ABB CYLON® TECHNICAL BULLETIN 531

# FBVi/FBTi v9.3.1 Default Serial Port assignment

Products Affected: FBTi-7T7-1U1R, FBTi-6T1-1U1R, FBVi-2U4-4T-IMP, FBVi-2U4-4T-SI, FBVi-2U4-4T, FBVi-2U4-4T-FA-IMP, FBVi-2U4-4T-FA-SI

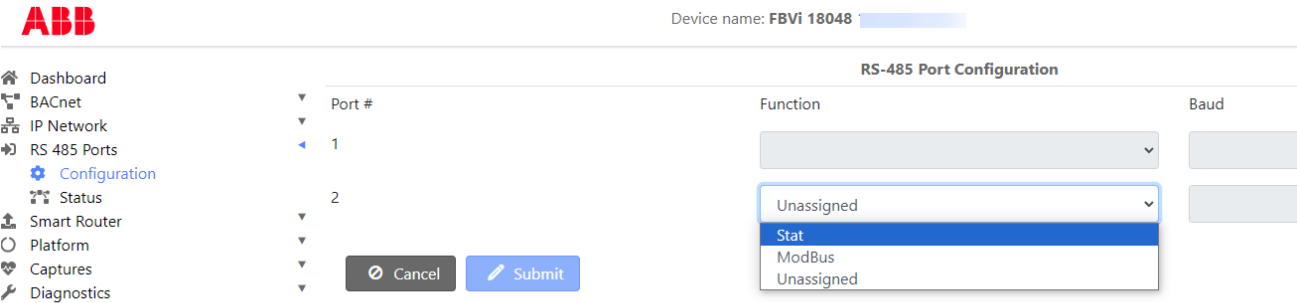
In v 9.3.1 firmware, FBVi/FBTi serial port is “Unassigned” by default.

In version 9.3.1 of the firmware, the port is set to Unassigned by default, so that the functionality must be selected manually in the configuration webpage:

In firmware versions 9.3.2 and later the default functionality will be Stat (FusionAir).

Customers who update to v9.3.1 must manually configure the serial ports on all FBVi or FBTi controllers connected to FusionAirs on the site.
